Noise From Fan Motor

Topic number	LI83.10-P-075602
Version	1
Function group	83.10 - Ventilation
Date	11/29/22
Validity	H243 left-hand drive vehicle, H247 left-hand drive vehicle
Reason for change

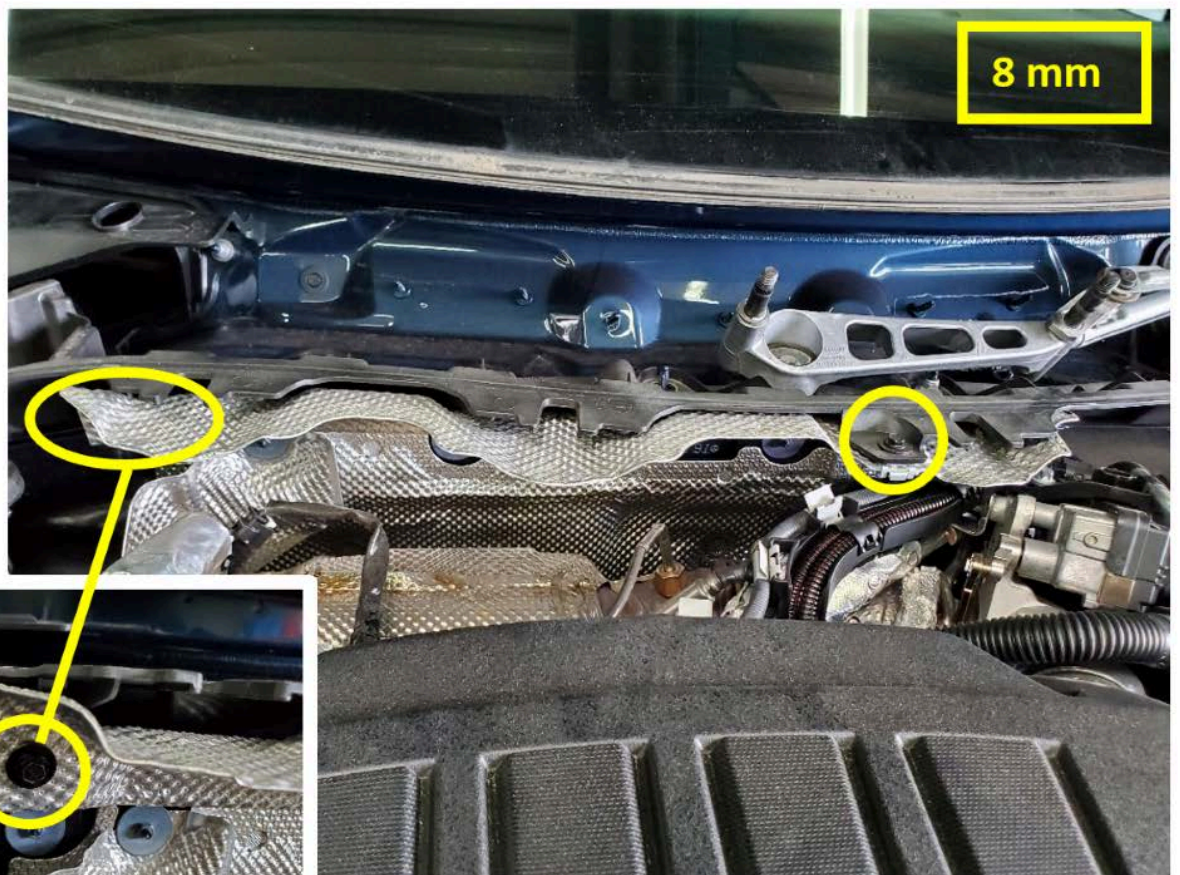
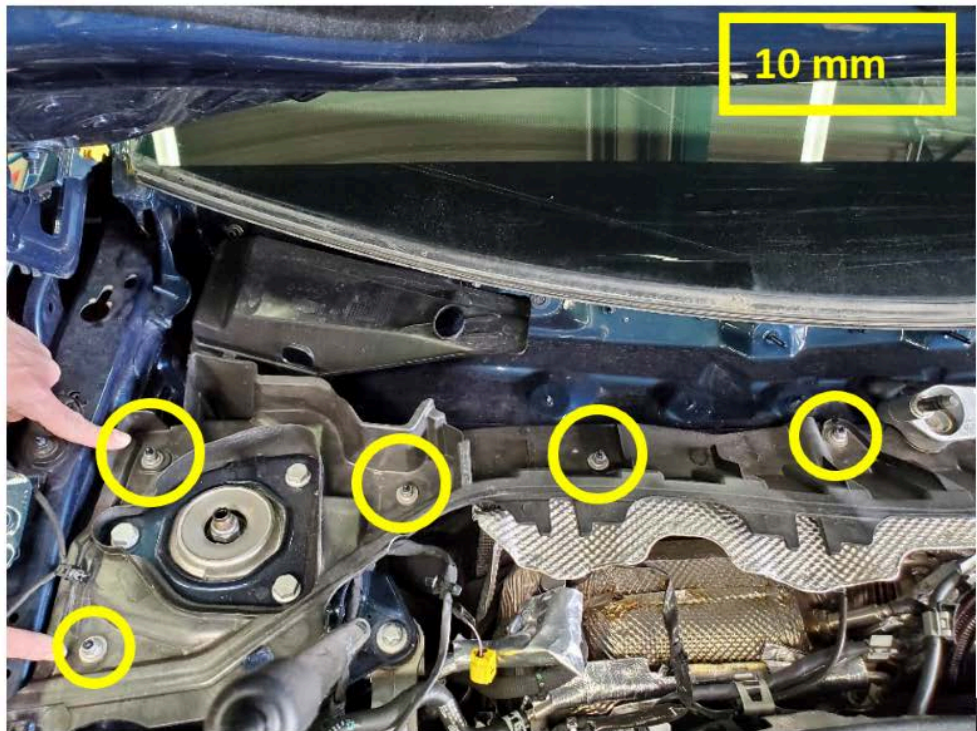
- 1- Remove windshield wiper as per the work instructions AR82.30-P-0001MFA
- 2- Remove cover for water drain as per the work instructions AR83.10-P-1411MFB
- 3- Release threaded connections (5x 10 mm, 2x 8 mm)

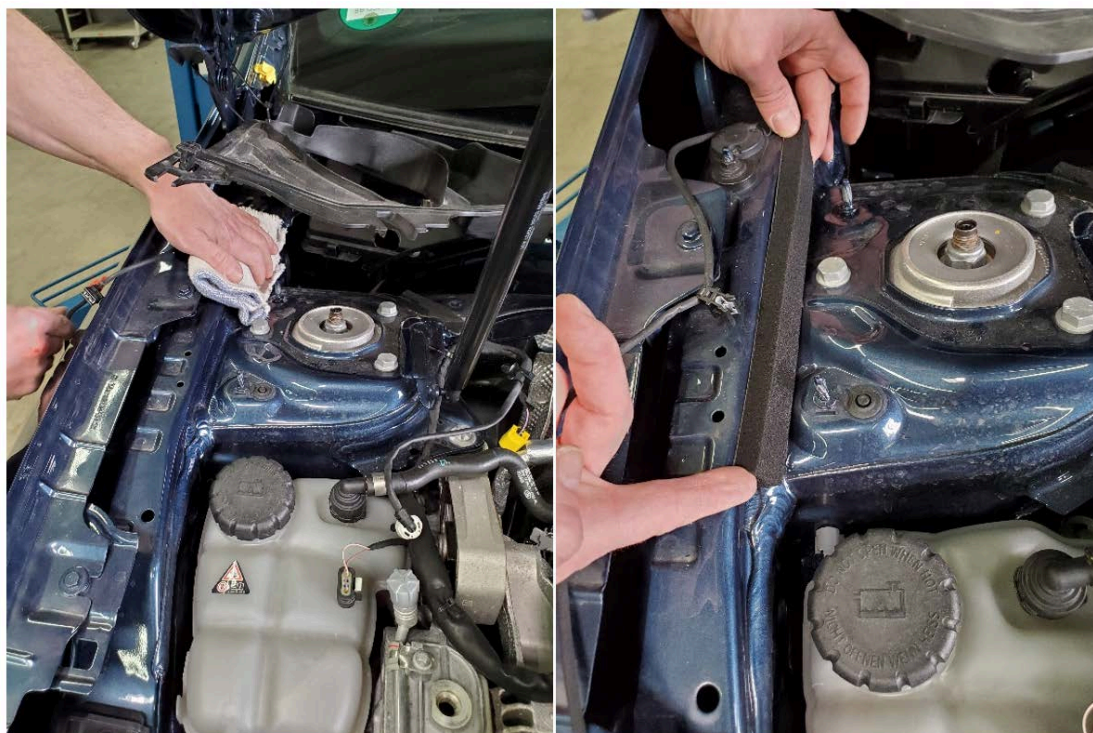
4- Fasten released part temporarily using cable tie to hood.

5- Thoroughly clean body between fender and wiper motor then mount the sealing frame (A 247 835 12 00) using the self-adhesive tape.

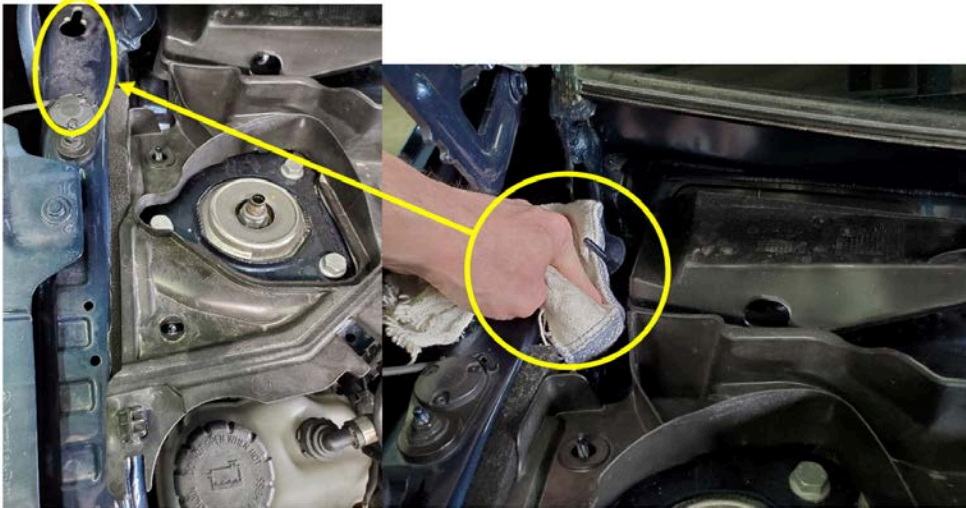
6- Cut cable tie and insert plastic part again. Then thoroughly clean the area behind the mounted sealing frame.

7- Open plastic cap on firewall then vacuum the filter using a vacuum cleaner. Then tighten the threaded connections again.

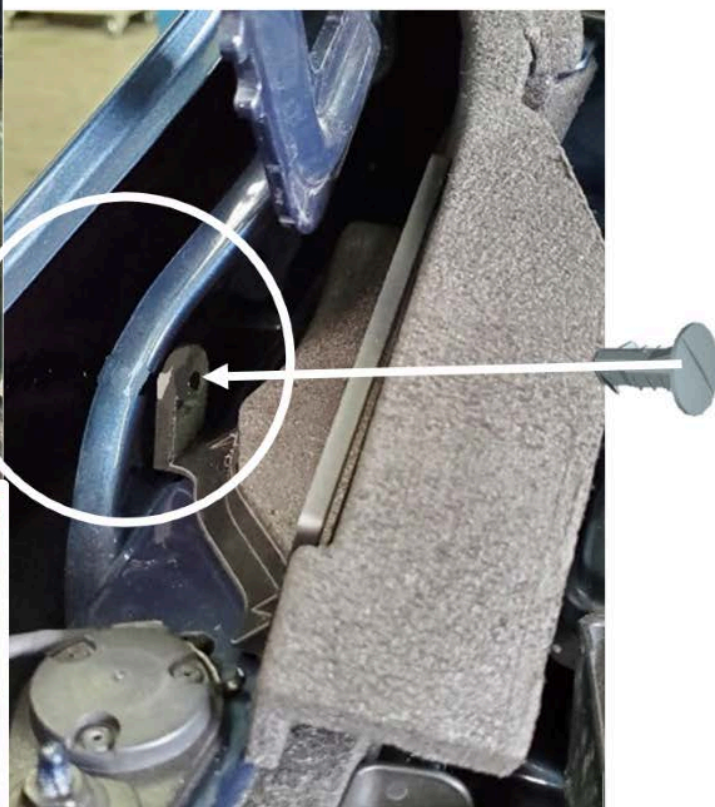
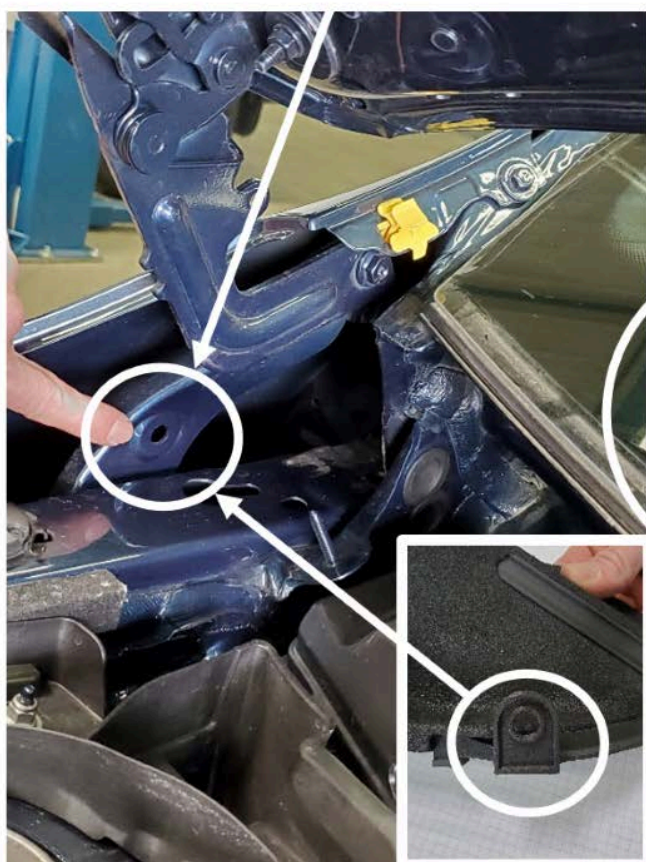
8- Finally, insert sealing frame (A 247 835 11 00) and attach to body-in-white using plug-in mounting (A 000 991 56 04)

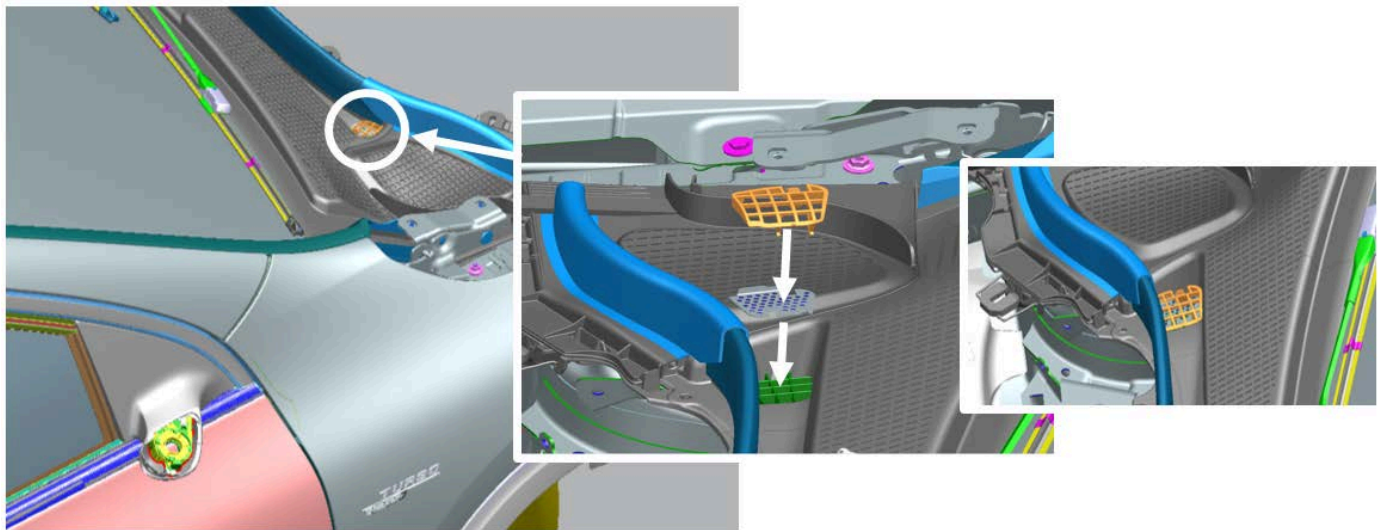
9- Assemble in reverse order.

10- Place housing cover (A 247 830 95 03) and housing cover (A 247 830 63 03) on top of each other.
